CHAIR: ROBERT GROHMANN
MEMBER: JIM SARCLETTI
MEMBER: DAN LESHER
MEMBER: MIKE SHERMAN
MEMBER: TINA ZELLMAN
ALTERNATE MEMBER: J.D. LUDFORD

Meeting Date:		May 5, 2022				
Item Name:		Site Plan & Design Review - Waconia Fire Station				
Originating Department:		Community Development				
Presented by:		Lane Braaten				
Previous Council Action (if any):						
Item Type (X only one):	Consent		Regular Session	X	Discussion Session

Provide a recommendation to the City Council regarding the Site Plan & Design Review application to construct a new fire station at 10451 10th Street West.

The applicant, on behalf of the City of Waconia, has submitted an application for Site Plan and Design Review for the property located at 10451 10th Street West. The application proposes the construction of a new fire station on the subject parcel.

1
E011
ELECTRICAL PHOTOMETRIC
1/16" = 1'-0"

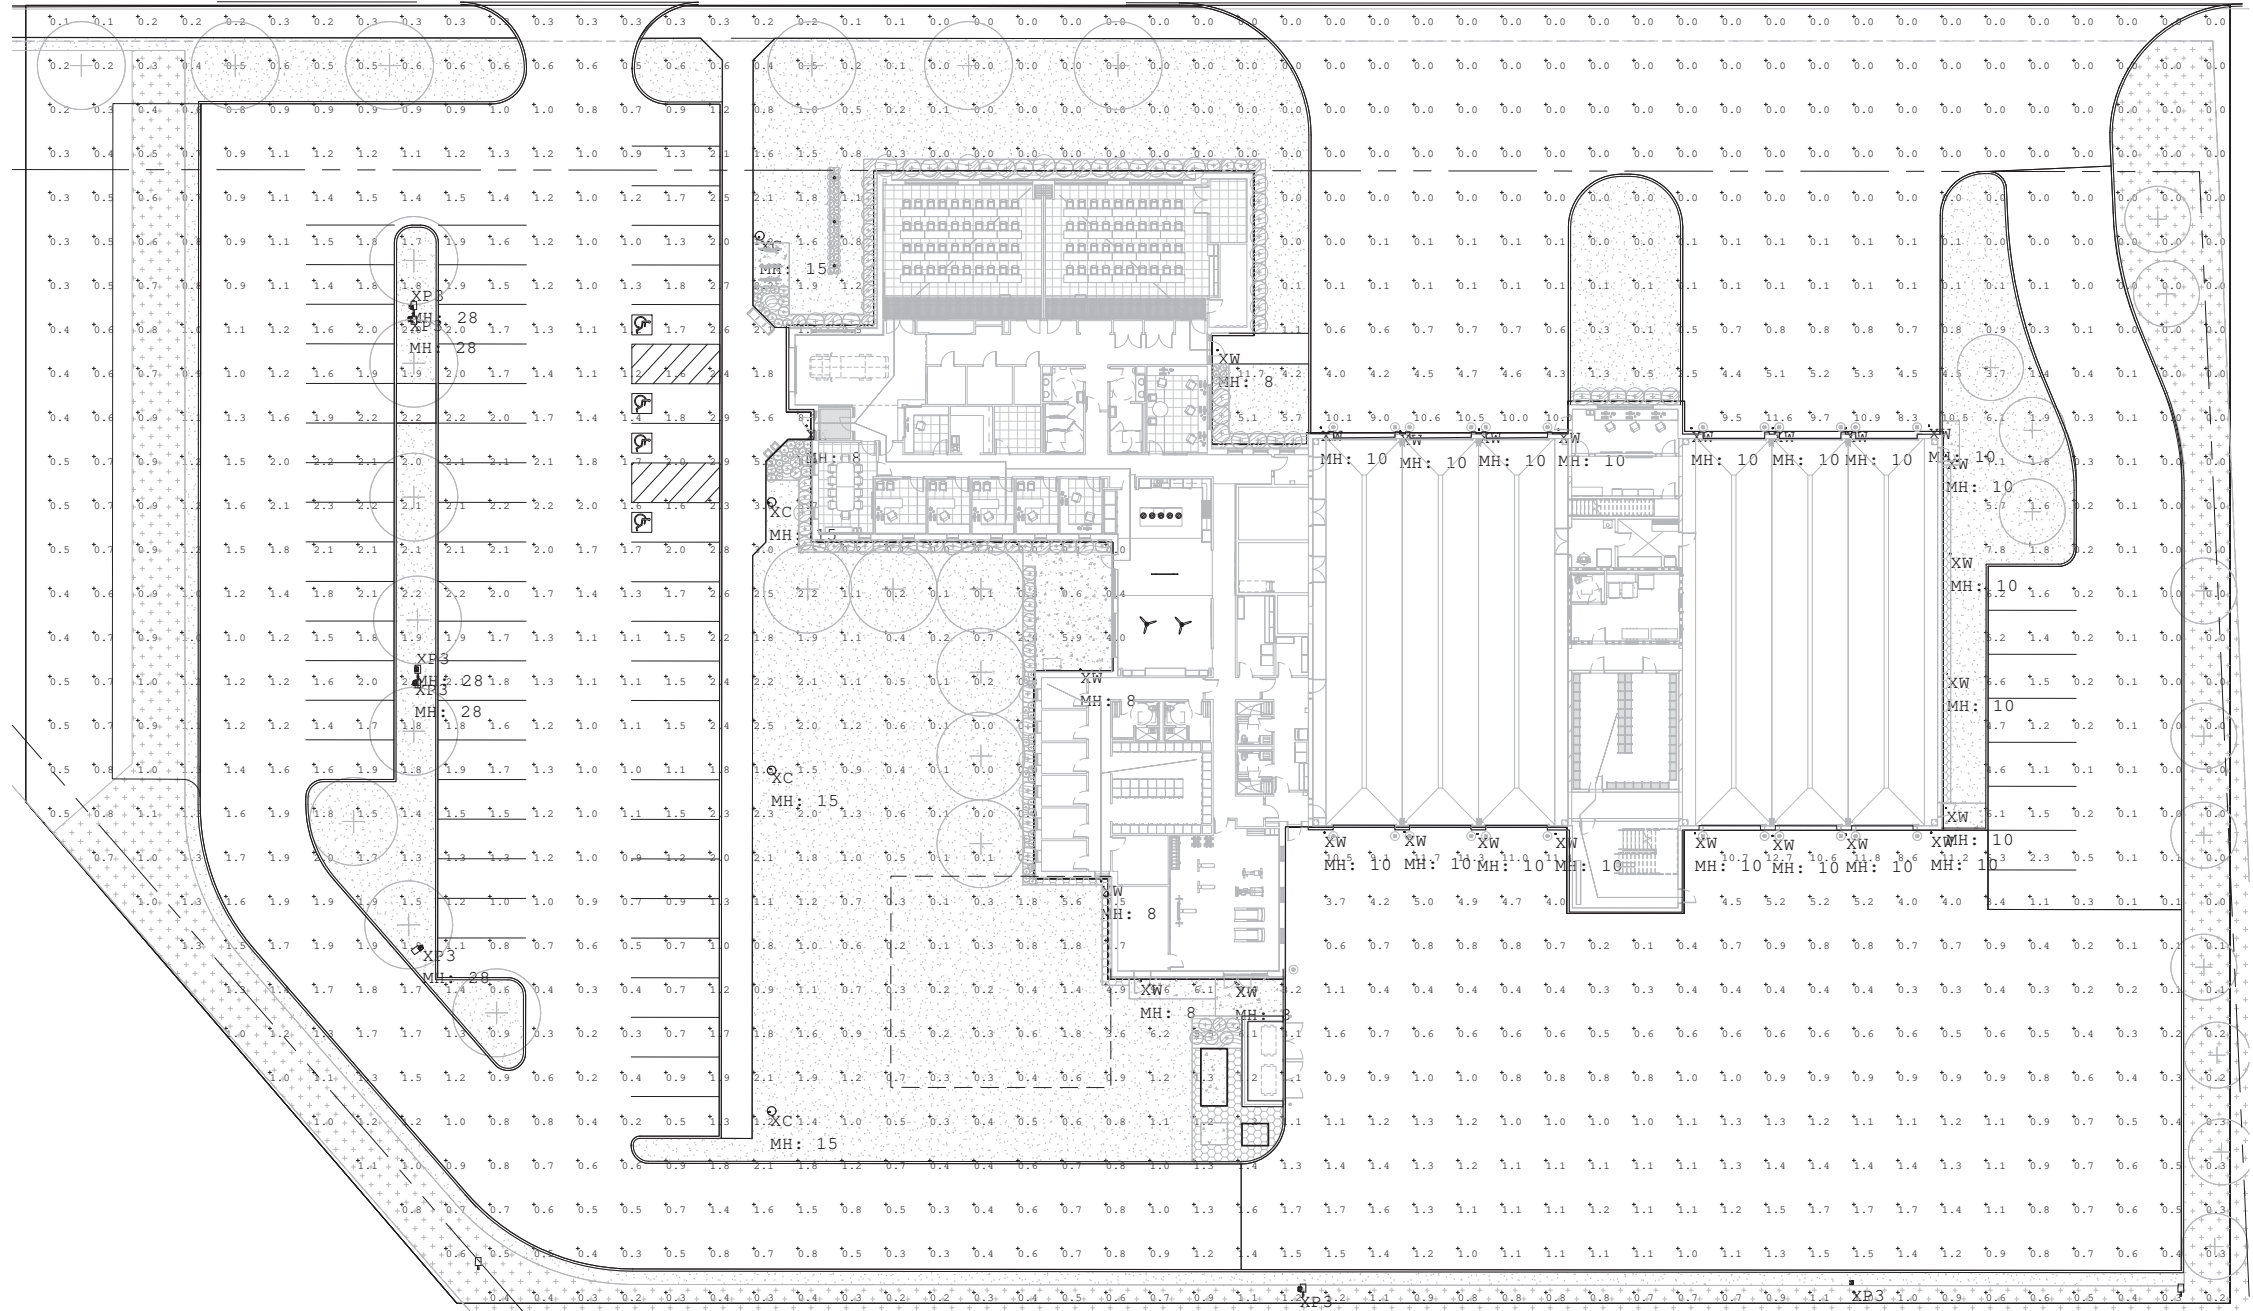
Section 900.08, Subd. 1.C provides standards for exterior lighting. The current lighting plan submitted by the applicant appears to conform to City Ordinance requirements.

PRELIMINARY TREE PRESERVATION PLAN	PROJECT NO: 21-0230
SHEET NO. 5 OF 5 SHEETS	DATE: 2-21-22

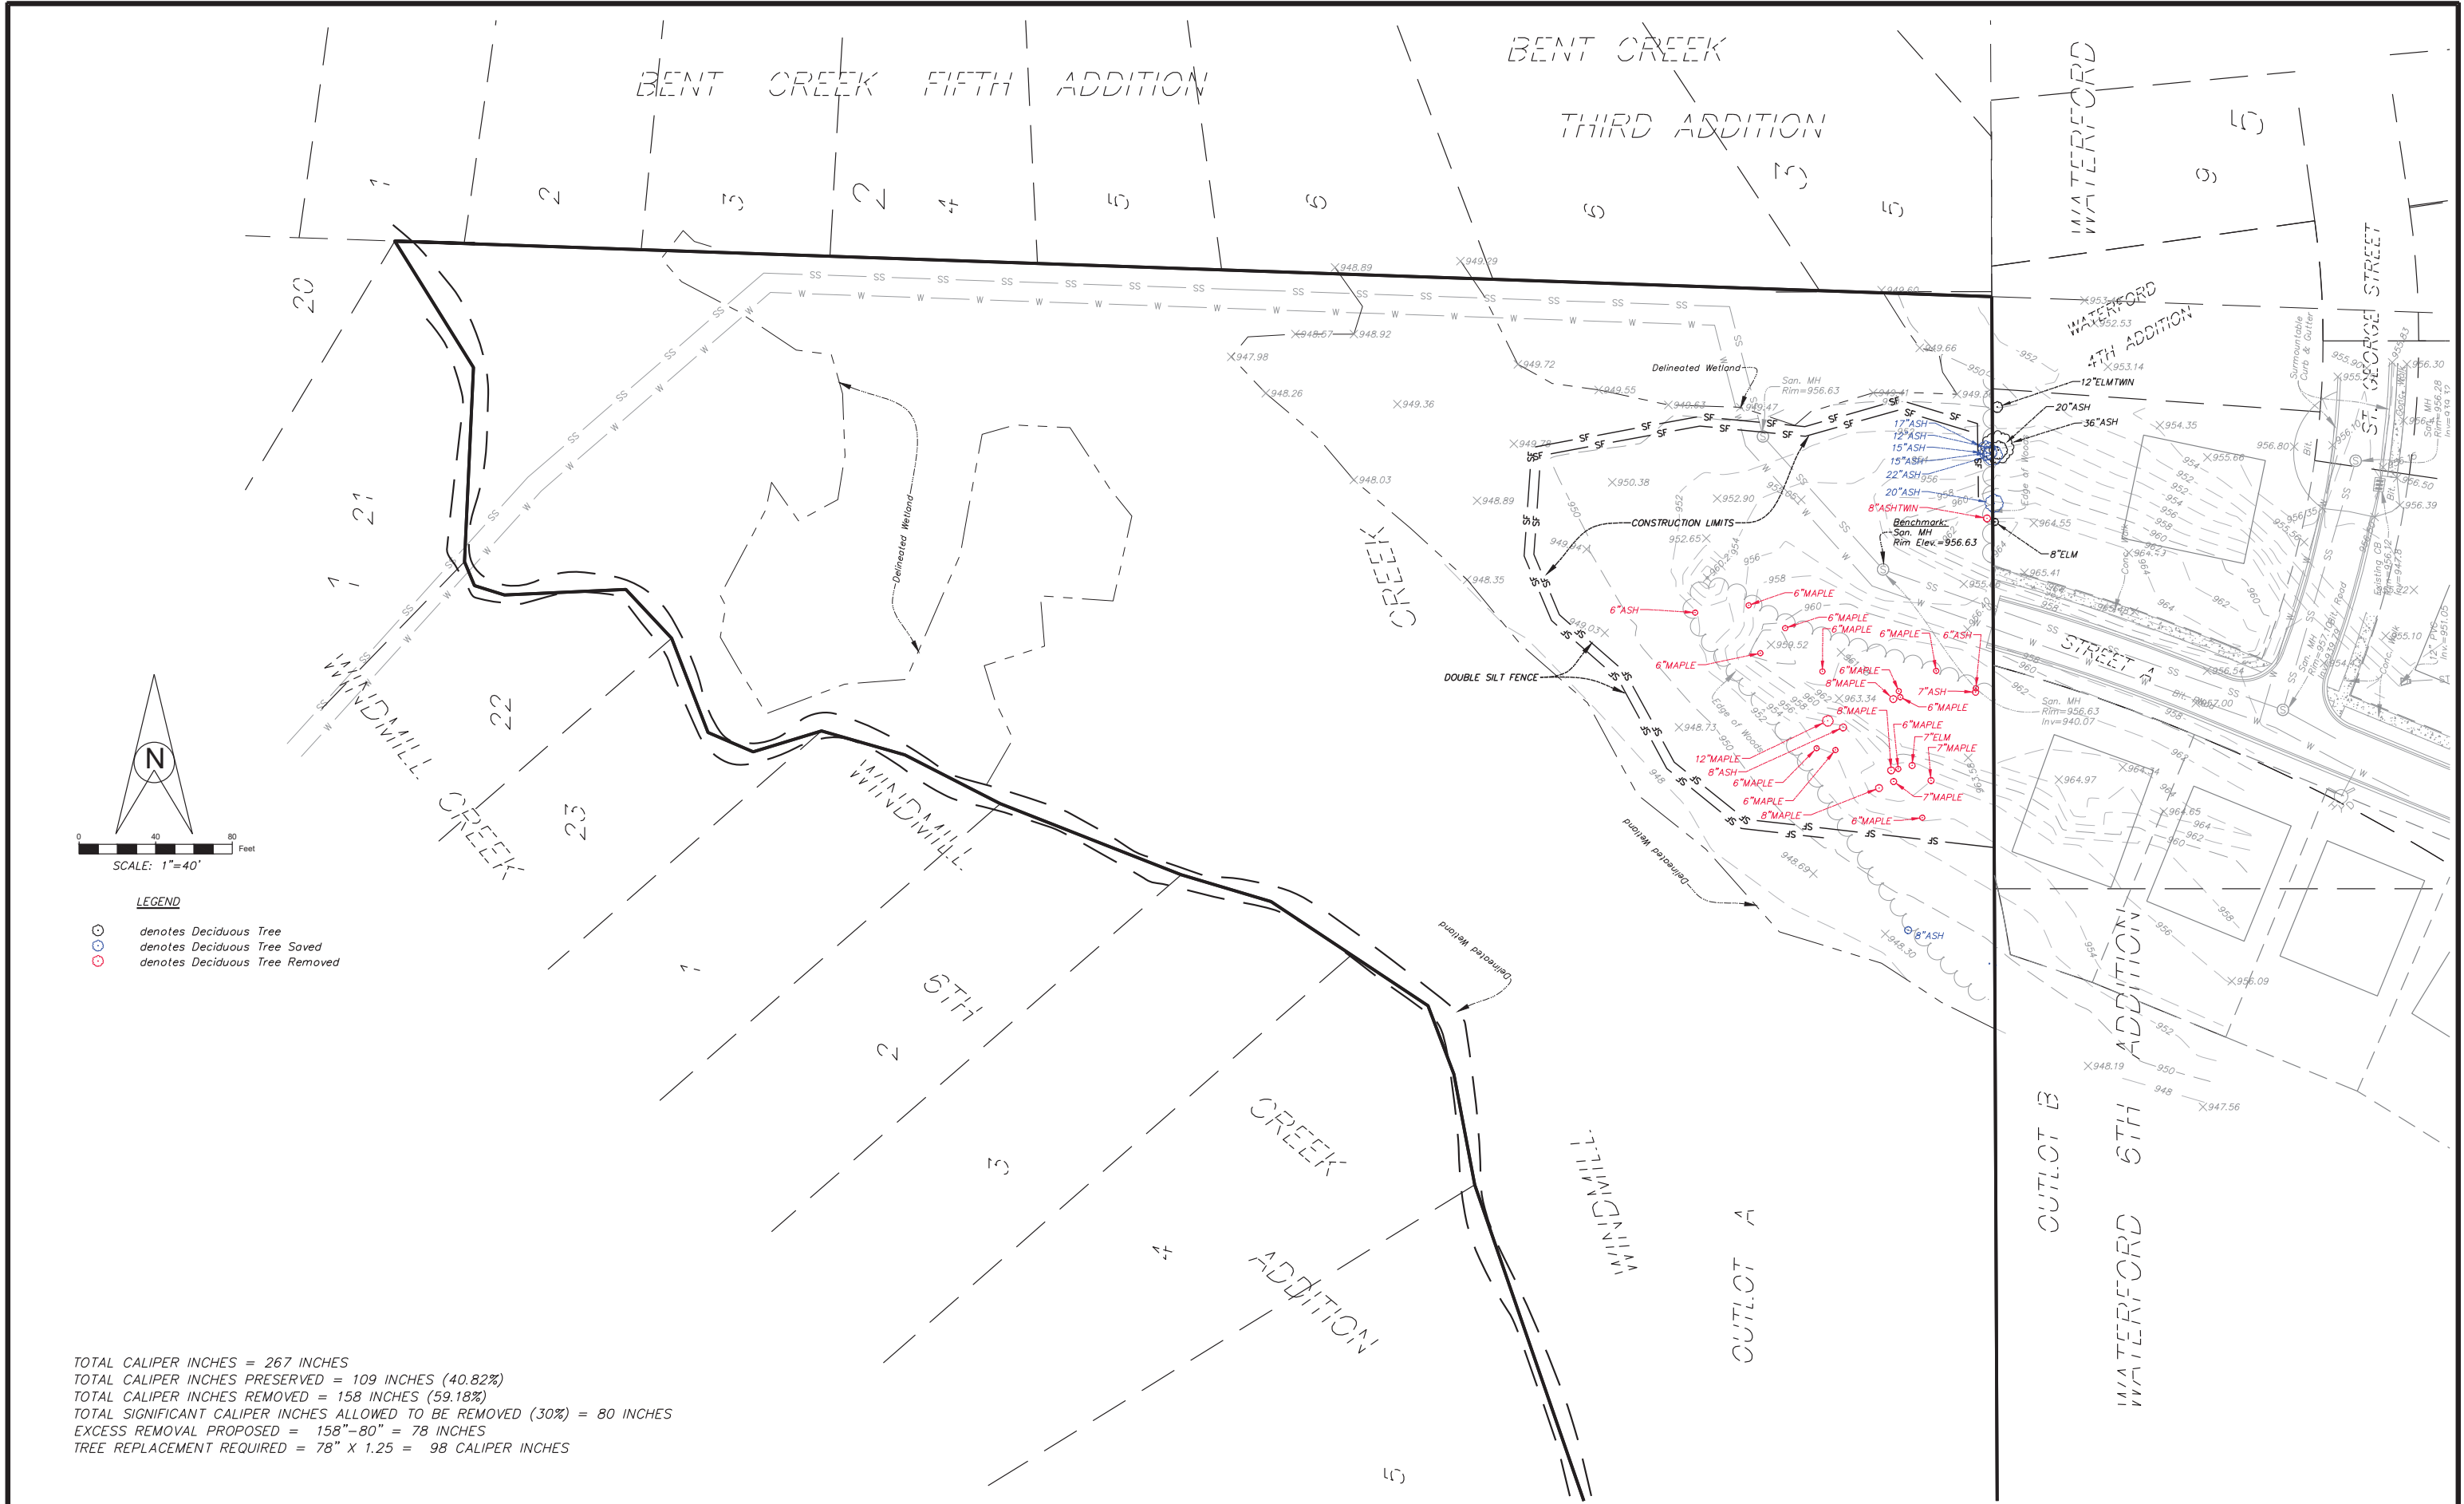
The applicant has provided a Preliminary Tree Preservation Plan for the areas proposed to be developed as part of the Windmill Creek 8th Addition plat. The area identified as Outlot A is heavily wooded and will require consideration and review of an additional tree inventory and plan prior to the development of said Outlot. The tree inventory, preservation and replacement details for the three residential lots are included below.

The required trees/caliper inches have been included in the landscape plan for the project. The tree preservation requirements for this project have been met.
